Horseheath Parish Council Objections to Application CCC/23/110/FUL

This proposal is for a new 11.17 hectare biodigestion plant on land owned by Streetly Hall Estates of which 7.55 hectares will be the plant itself. The site is on the corner of Dean Road and Webbs Lane.

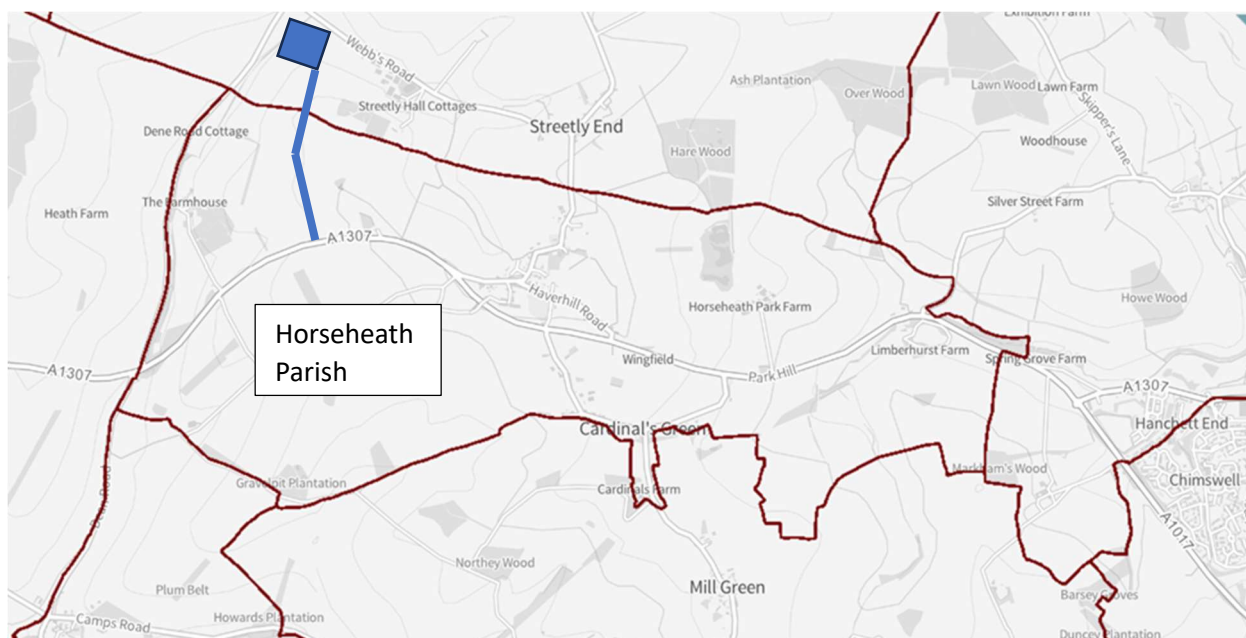
The plant itself is in the Parish of West Wickham and Streetly End; the southern 500m of the access track to join the A1307 is in Horseheath Parish as this schematic drawing shows:
